Safety recommendation: AIC 19-R21/18-1002

Addressed to: Avions de Transport Regional (ATR) Limited

Investigation link: AIC 18-1002

AIC assessment of BEA response to *Recommendation AIC 19-R21/18-1002* issued to Avions de Transport Regional (ATR) Limited.

ATTACHMENT 1: ACW GEN 1/2 LOSS CHECKLIST

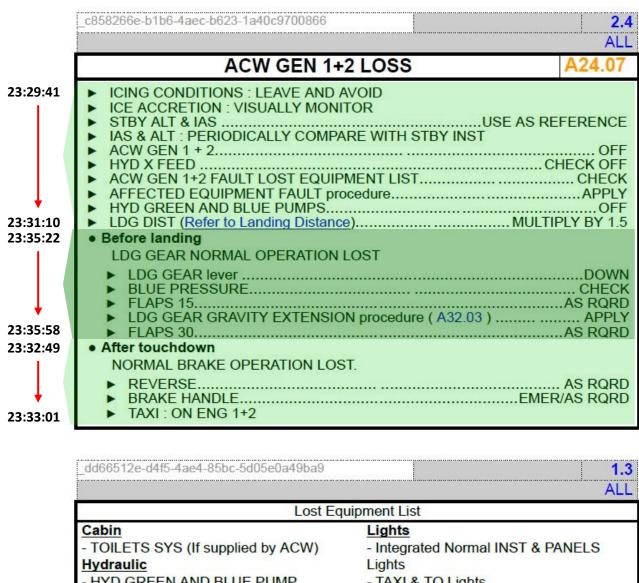
During the 'ELECTRICAL SMOKE' checklist actions, the crew were referred to the 'ACW³ GEN 1+2 LOSS' checklist (See attachment 1). The aircraft was on descent, more than 20 nm from the aerodrome and was not yet within the appropriate speed range to be configured for landing. Therefore, the PIC instructed the copilot to 'skip' the 'before landing section' of the checklist. That section contains essential action items for the configuration of the aircraft, such as the landing gear extension and flap selection. The crew subsequently returned to that section of the checklist and completed it when the aircraft was within 5 nm of the aerodrome and the speed had fallen to within the appropriate range.

The pilots did not refer to the normal 'BEFORE LANDING' checklist (See attachment 2), which also contained the above action items and additional essential action and check items, including the rudder Travel Limiting Unit (TLU). The investigation determined that they substituted the normal 'BEFORE LANDING' checklist with the 'ACW GEN 1+2 LOSS' checklist, before landing section.

As a result, the QRH did not draw the pilots' attention to check the TLU indicator and switch to ensure they had set it to the low speed mode. The TLU remained in the high-speed mode, which restricted rudder deflection to only +/- 4° instead of the its normal full available deflection of +/- 27° . In the absence of hydraulic steering capabilities, aerodynamic steering on the ground was absolutely necessary. However, the extremely limited rudder authority rendered aerodynamic control negligible.

- 1. The rudder *Travel Limitation Unit (TLU) Low Speed* check, along with other essential check and action items, is included in the before landing section of the *'Alternating Current Wild (ACW) GEN 1+2 LOSS'* checklist, and every abnormality and emergency checklist that has gear and flap extension procedures; or
- 2. the *Quick Reference Handbook (QRH)* contains appropriate information that informs the crew that the *before landing sections* of the 'ACW GEN 1+2 LOSS' checklist and other abnormality and emergency checklist is not a substitute for the normal 'Before landing' checklist.

ATTACHMENT 1: ATR AIRPLANE FLIGHT MANUAL, REVISION 29.0 – TOTAL JUNE 2021

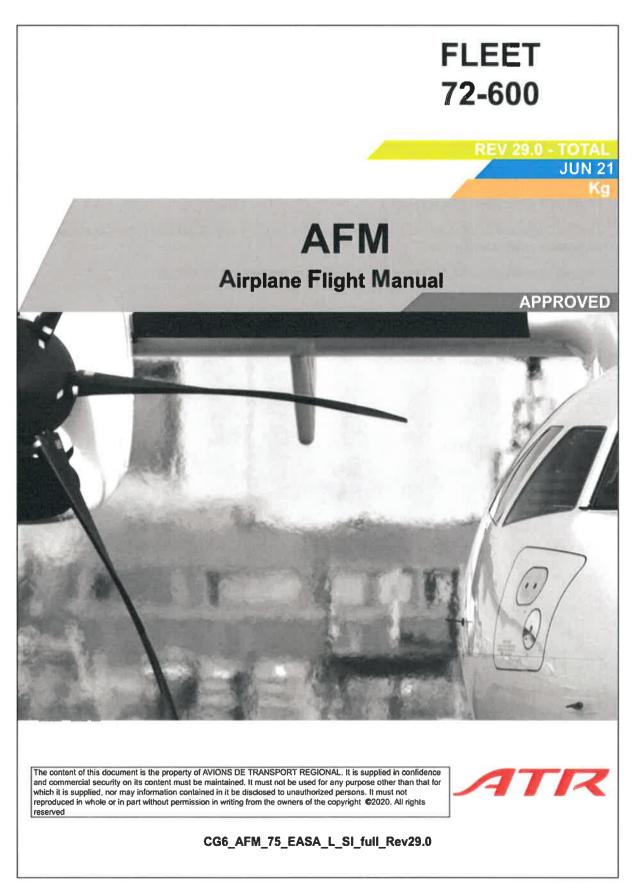
In June 2021, Avions de Transport Regional (ATR) Limited issued an Airplane Flight Manual (AFM) revision that addressed the safety deficiencies identified in AIC Safety Recommendation AIC 19-R21/18-1002. (See Attachment 1.)

- Caution added to avoid human factor ambiguity.Standardization of TLU actions wording.	AFM.PRO.NNO.EMR.99.10.E99.10 UNRELIABLE AIRSPEED INDICATION ALL
